ADDENDUM NO. 4

TOWN OF WINDHAM INTERMODAL TRANSPORTATION CENTER

DATE OF ISSUANCE: June 24, 2019 WALKER PROJECT #: 16-2958.00
OWNER: Town of Windham

- Sketch SK-2

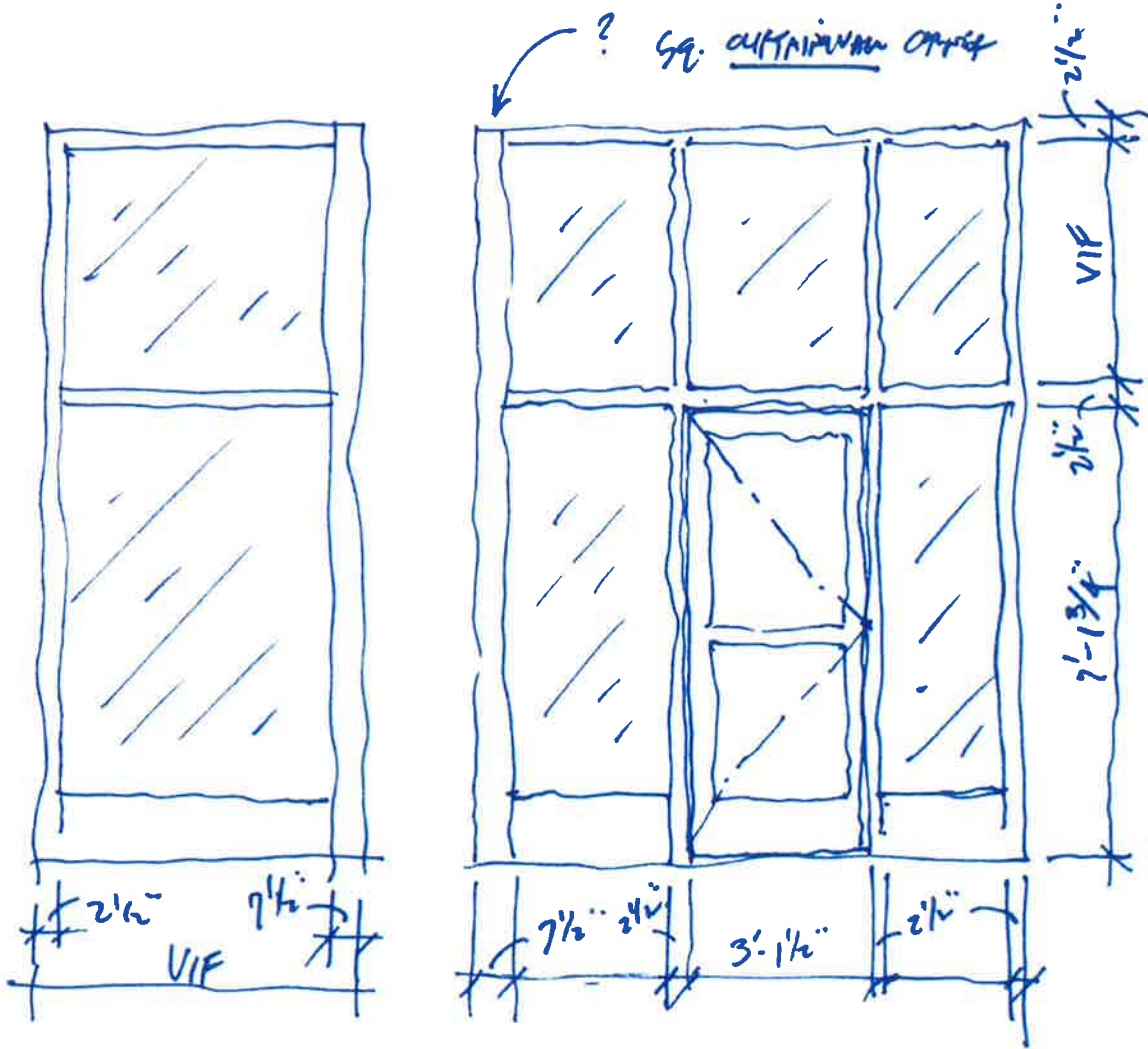
73. Question - Please provide elevation for interior storefront in Commercial Space 103 to confirm layout and materials.
- a. Response – Refer to attached Sketch SK-2 for general intent for the system. System shall be 7.5" glazed curtain wall spanning from floor to underside of structure above.
